DEPARTMENT OF BUILDINGS THE CITY OF NEW YORK
FOR THE BOROUGH OF MANHATTAN.

Amendment to Application No. 2427 Alt., 1907. B, 190

Location 127 Seventh Street.

AMENDMENT

SPF
Plan No. 24

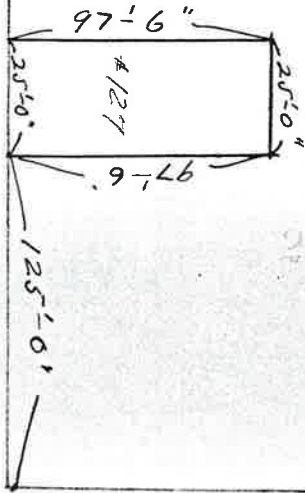
BEGINNING at a point on the Northerly side of East Seventh Street, distant 125'-0" feet West from the corner formed by the intersection of East Seventh Street and Avenue A running thence Northerly 97'-6" feet; thence Westerly 25'-0" feet; thence Southerly 97'-6" feet; thence Easterly 25'-0" feet to the point or place of beginning.
